**Kew Residential Services
115 Princess Street, Kew
Construction of an Apartment Building**

I refer to your letter dated and received on the 24 June 2014, including Walker Corporation documentation for the construction of a 5 level apartment building with 2 levels of basement car parking. Please find documented below Council's comments/concerns in respect to the proposed application:-

WALKER DEVELOPMENT PLAN - KEW MAP

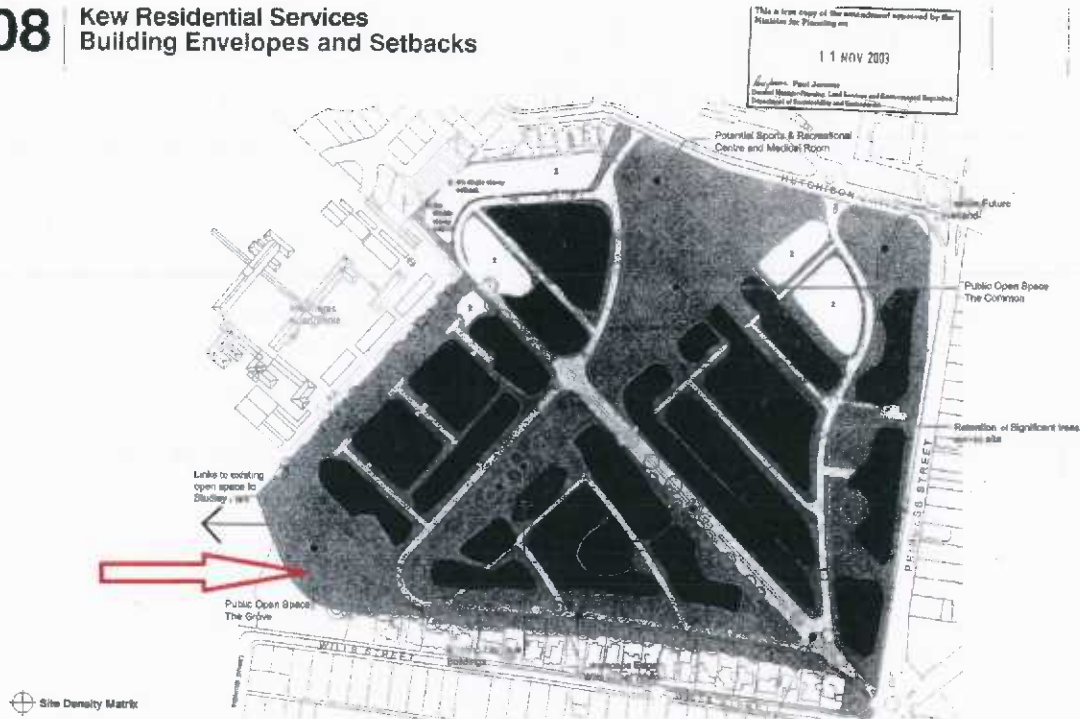
Council considers the proposal is not in accordance with the approved Walker Development Plan (WDP). The proposed location of the apartment building is located within an area that has been earmarked for public open space (see diagram below).

The approved Urban Design Framework Plan (October 2003) also clearly identifies this area as public open space and identifies this land as a link through to the public open space in Yarra Bend Park. Council does not support a development which is located in an area which should be set aside as a link for open space. In addition, Council questions how a permit may be granted for a building that does comply with either the WDP or the UDF?
